ADMINISTRATIVE DECISION - MINOR HISTORIC REVIEW

CASE NO. Historic Review Case HIS15-36 / Amanda No. 15-116545-DR

REQUEST: Minor historic design review of a proposal to install a new furnace vent pipe on the roof of the A.C. Gilbert House, a new entrance sign on the Rockenfeld House, and install new lighting in the courtyard pergola and covered walkway within the A.C. Gilbert Discovery Village which includes the A.C. Gilbert House (1887), individually listed on the National Register, and the Rockenfeld House(1883) and Parrish House(1910) Salem Local Landmarks, located at 116 Marion Street NE, 97301; Marion County Assessor Map and Tax Lot number: 073W22DB 07400.

New Furnace in Gilbert House 2014

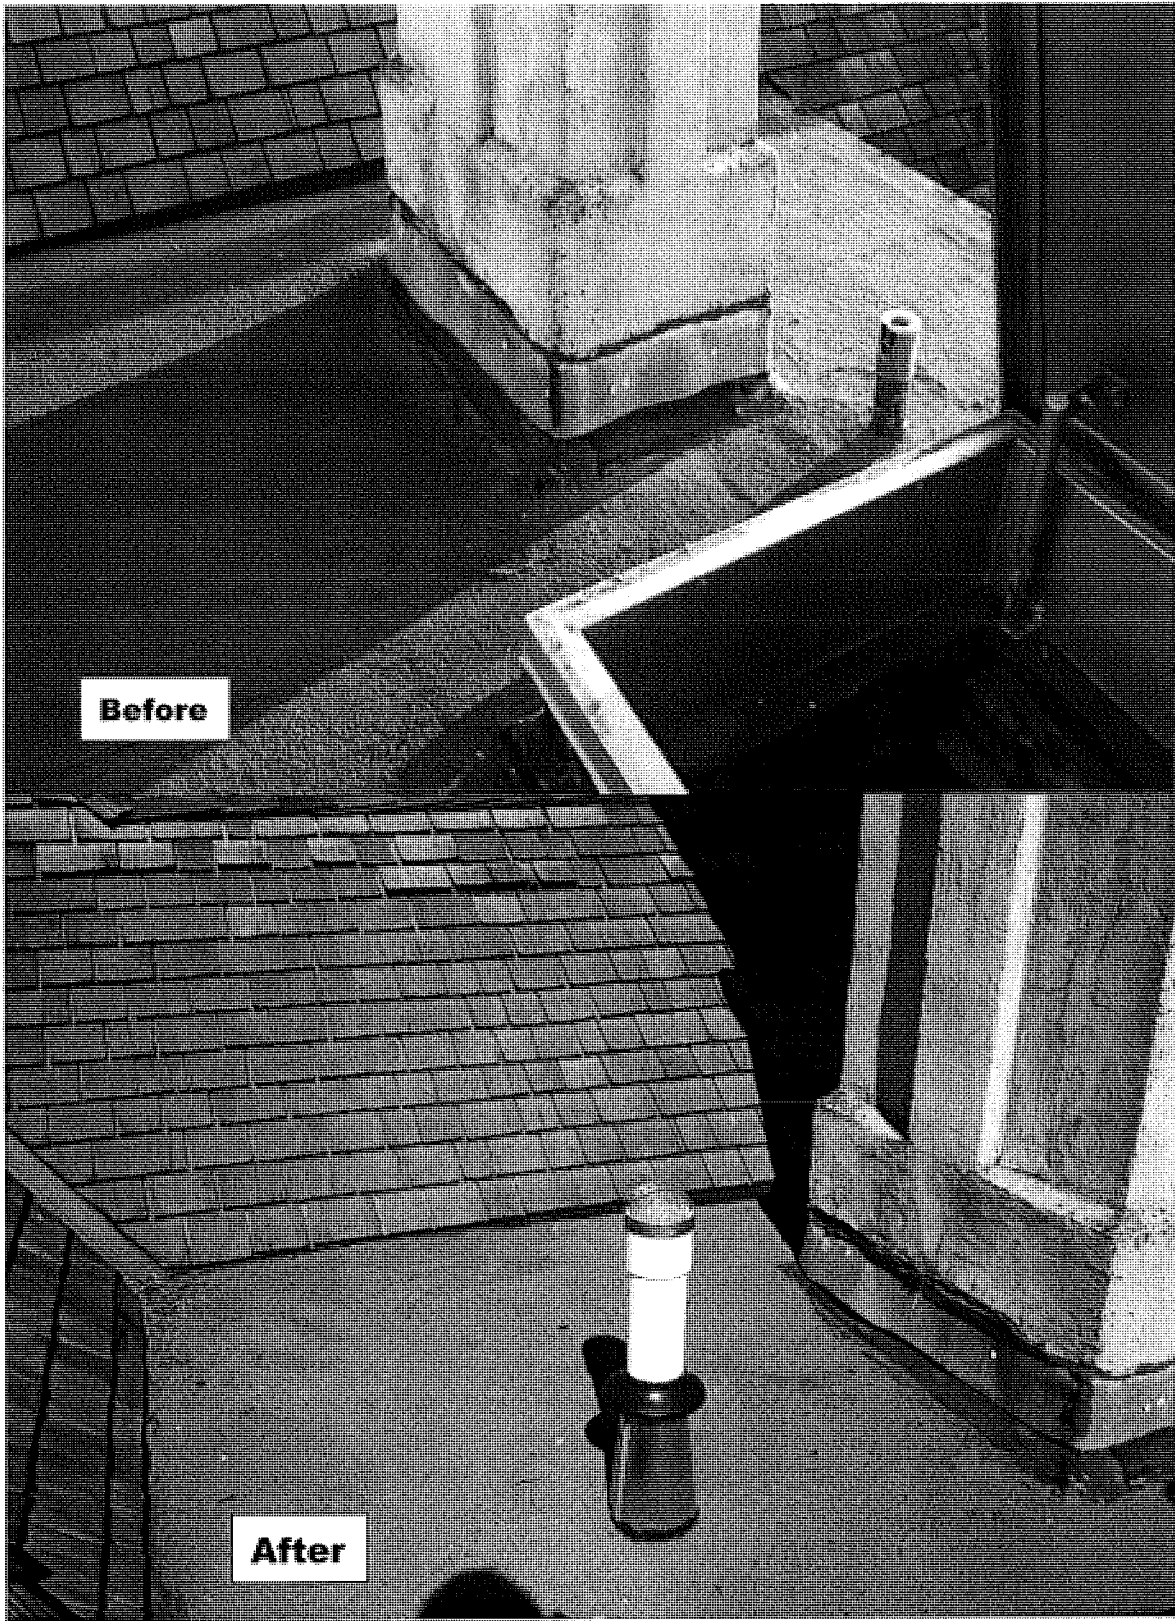
Vent Pipe Finding: The vent pipe is approximately 30" high and 6" in diameter, located at the center of the flat roof at the south end of the A.C. Gilbert House, not visible from the right of way, thereby meeting SRC 230.060(I)(2)(A).

Vent Pipe Finding: The vent pipe is approximately 30" high and 6" in diameter, located at the center of the flat roof at the south end of the A.C. Gilbert House, screened from view and not visible from the right of way, thereby meeting SRC 230.060(I)(2)(C).

Discovery Village Walkway Lighting

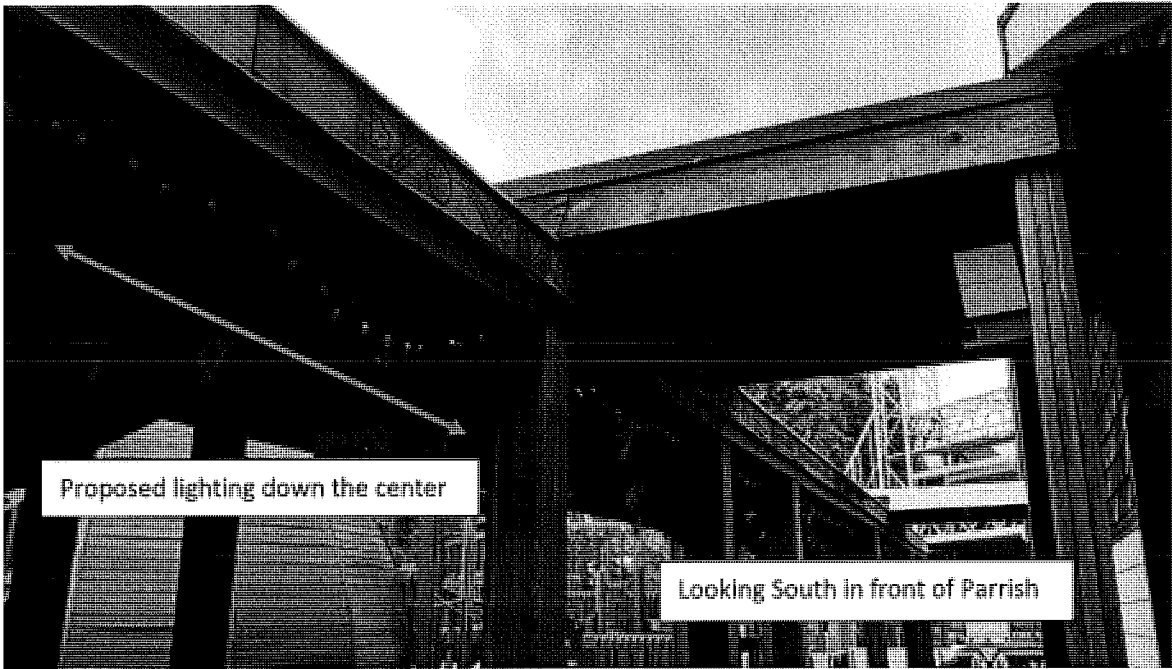
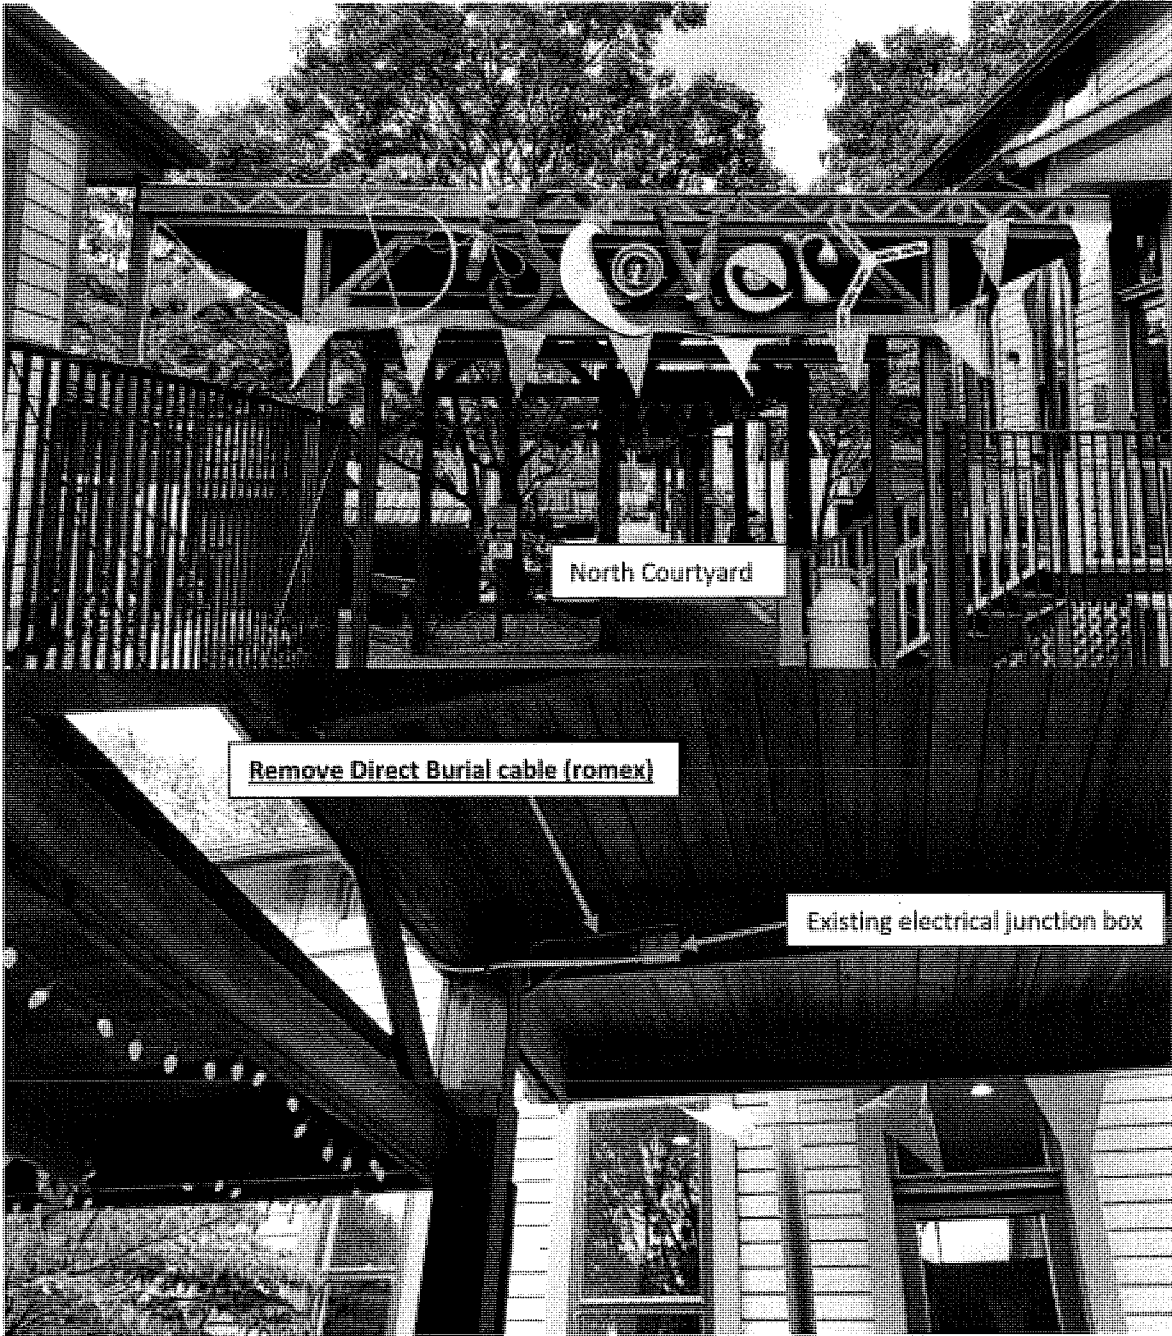
Lighting Finding: The proposed lighting is designed as an integral part of the walkway and courtyard adjacent to the historic buildings, and the associated electrical cables, equipment and junction boxes will be located out of public view, thereby meeting SRC 230.060(I)(2)(A).

Lighting Finding: The proposed lighting and associated equipment will be recessed above the walkway, and designed as an integral part of the courtyard and signage thereby meeting SRC 230.060(I)(2)(B). All currently visible direct burial cable and unused electrical boxes will be removed.

Entrance Sign

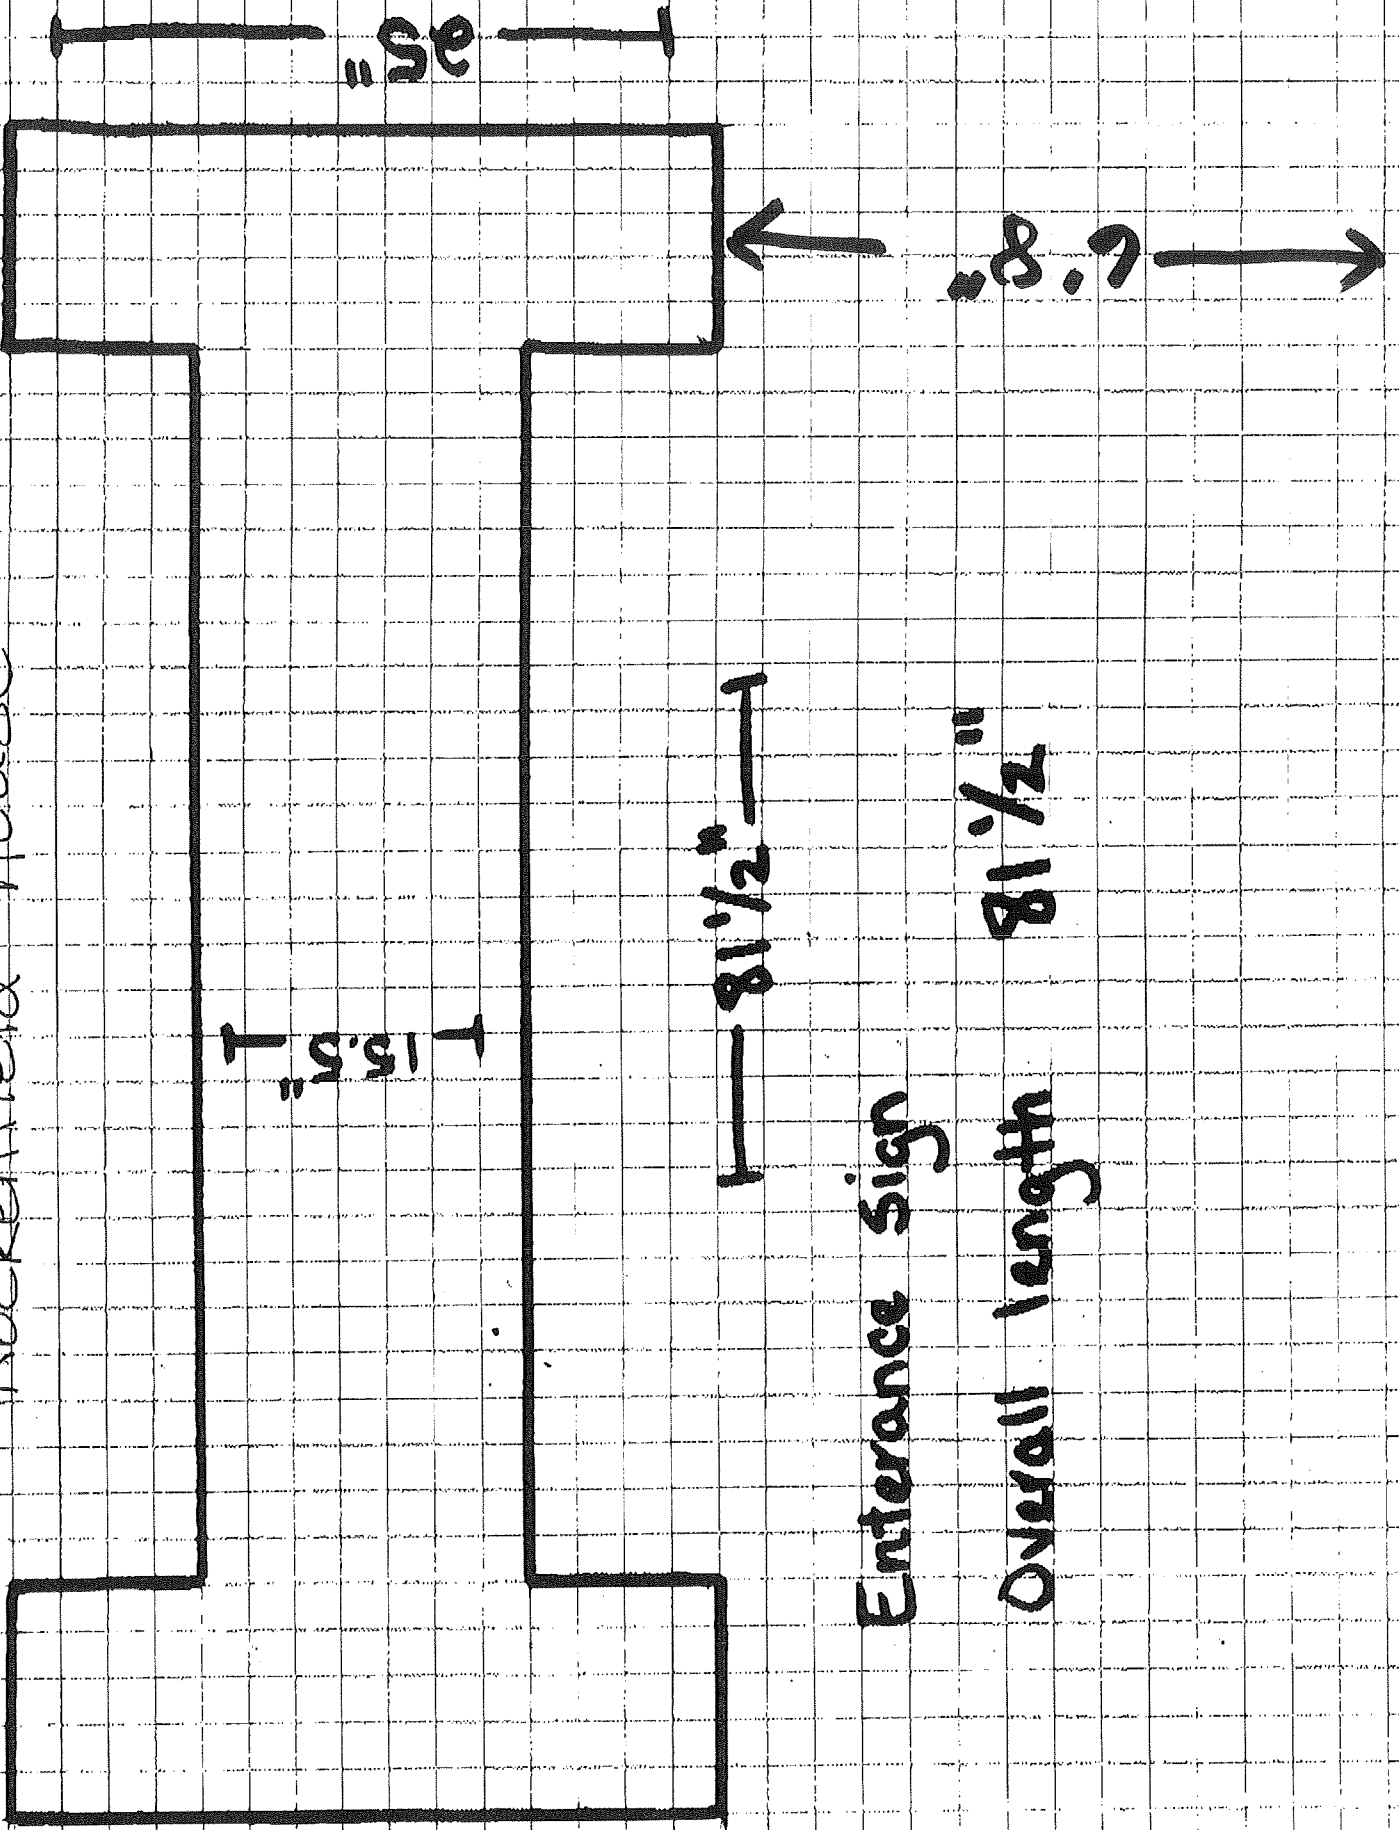
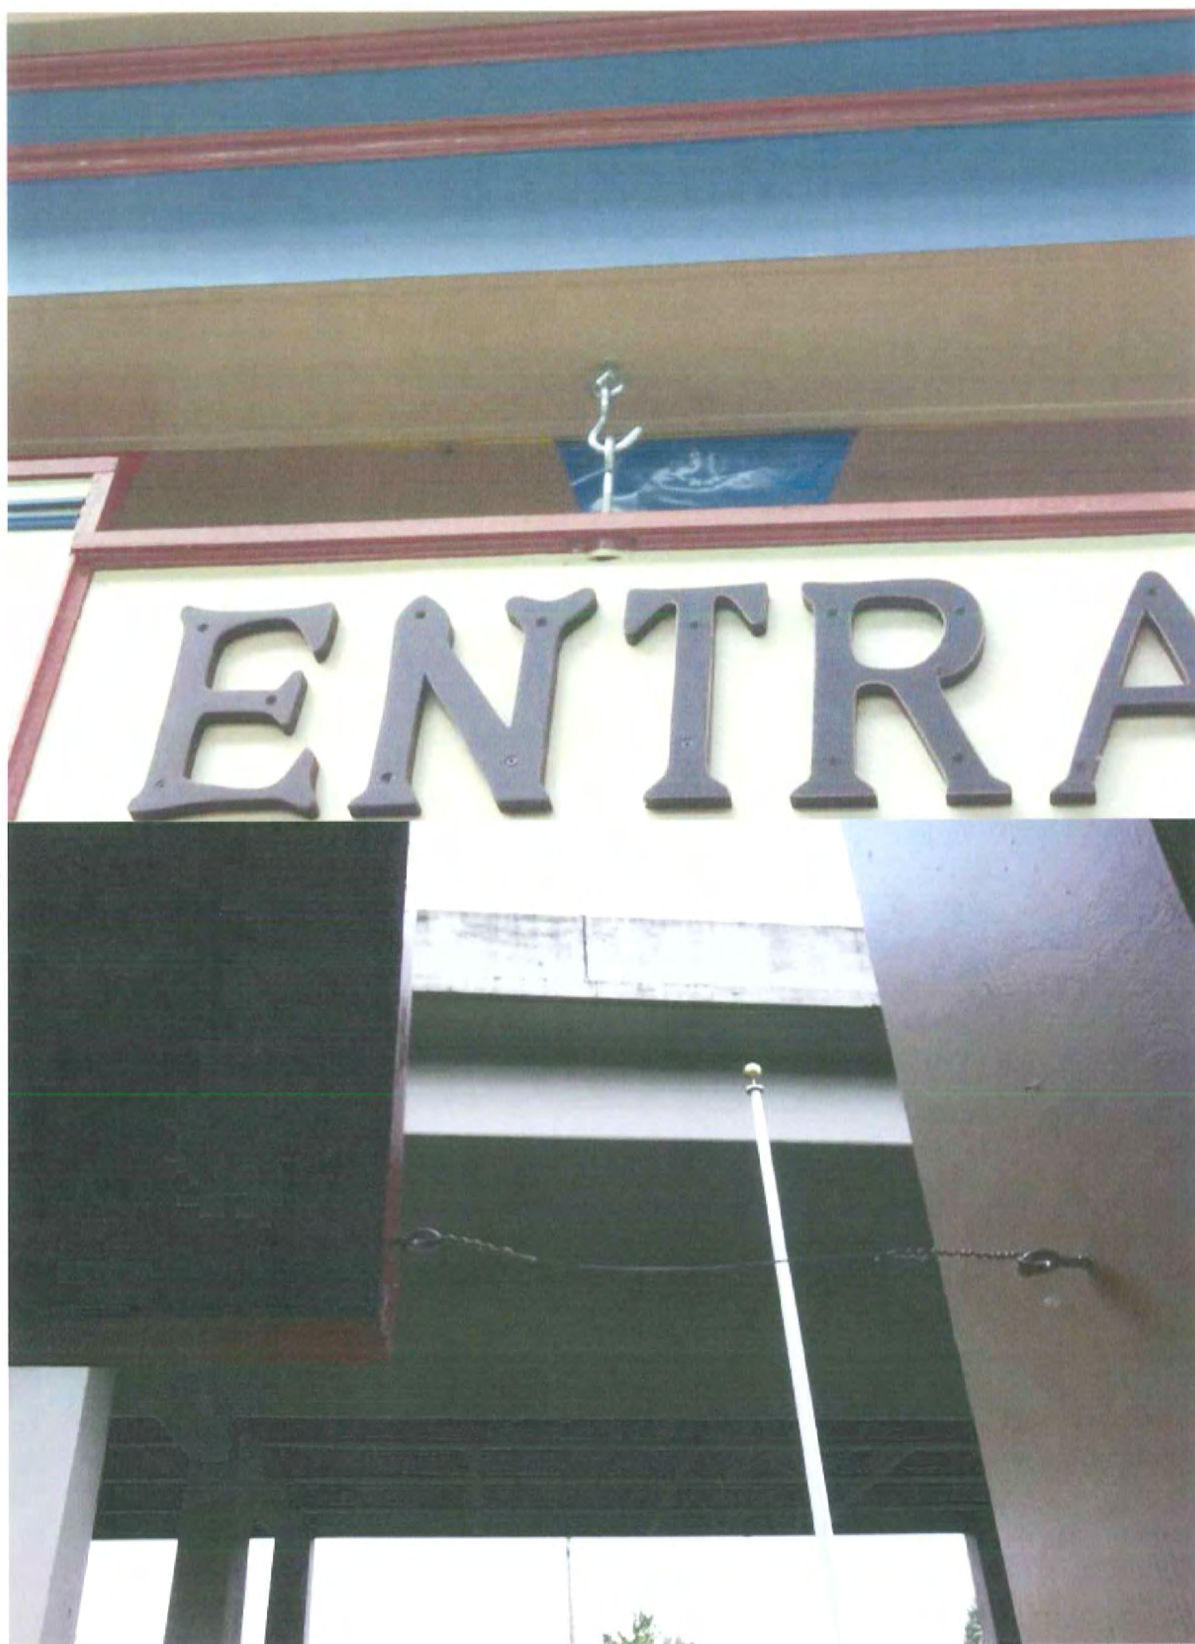
Finding: The sign is of wood, and is 81½" x 25", in a t-bone shape with dark letters on a light background. The sign is compatible with the Rockenfield house, thereby meeting SRC 230.062 (c)(1).

Finding: The sign is hung from metal brackets above the main entry to the Rockenfield House. The method of attaching the sign is the minimum reasonable to ensure limited damage to the existing siding and trim on the Rockenfield house, thereby meeting SRC 230.062 (c)(4).
